TECHNICAL SERVICE BULLETIN			
DATE ISSUED	Model Year(s) Affected	MODEL(S) AFFECTED	TSB #
March 31, 2004	1999 – 2004	DP as noted below	247
	BRAND		Түре
All 🗖	Dutch Star	Mountain Aire Kountry Aire	All 🗆 T T 🗆 F W 🗖 C A 🗖
Scottsdale 🛛	Kountry Star Northern Star	Essex  London Aire	$DP \blacksquare DB \square$
<ul> <li>Air Conditioning &amp; Heating</li> <li>Appliances &amp; Accessories</li> <li>Cabinets &amp; Furniture</li> <li>Chassis Components</li> <li>Chassis Components</li> <li>Plumbing &amp; Bath Components</li> <li>Construction Components</li> <li>Windows, Awnings, Vents, &amp; Doors</li> </ul>			
RECOMMENDED SOLUTION         See attached Technical Service Information and illustrations for diagnostic and repair procedures for this condition. Contact your Newmar Warranty / Technical Service Representative if you have questions.         The labor time for this repair is .3.         The Flat Rate Labor Code is 25 45 43 02.         Please mark your claim accordingly.

## **Technical Service Information**

**Issue:** When raised to full extension, power step well cover sags under a load.

## **Power Step Cover TSB Illustration**

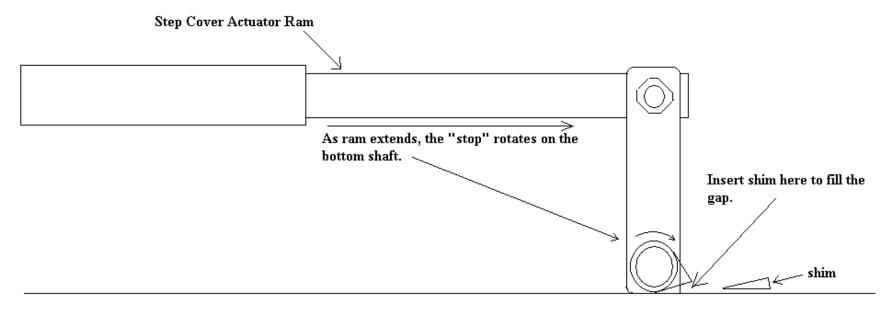
<u>Cause:</u> Limited "Ram" extension. When extending, the ram shaft pushes an arm on the shaft that rotates to lift the steps into place as a platform. If the ram stops short of the point where the "stop" piece that rotates with the shaft presses against the base of the assembly, the rotating shaft will not have adequate support. This causes the rotating shaft to bend under weight. The flex in the shaft allows the step well cover to sag when weight is placed on it.

1) Raise the steps to full extension. Inspect the rotating "stop" piece as noted in the attached photo to see if it is physically touching the base of the mechanism. If it is, there is no repair required.

At full ram extension, the "Stop" must be in physical contact with the base of the step cover assembly. If it is not, shim the opening so there is a hard rest for the "stop" to press against.

**<u>Cure:</u>** Shim the mechanism to provide support at full extension.

2) If there is a gap, determine the size of shim to be installed (usually a  $1/8^{\text{th}}$  or  $1/16^{\text{th}}$  inch shim), and fabricate one to fit.

3) Retract the step cover approximately an inch to allow insertion of the shim. Once in place, extend the step cover to full extension to be sure the rotating "stop" is resting firmly on the shim. This supplies physical support for the rotating "stop" piece on the shaft when the ram is at full extension, eliminating the sag and helping the rotating shaft maintain it's position and torque load.
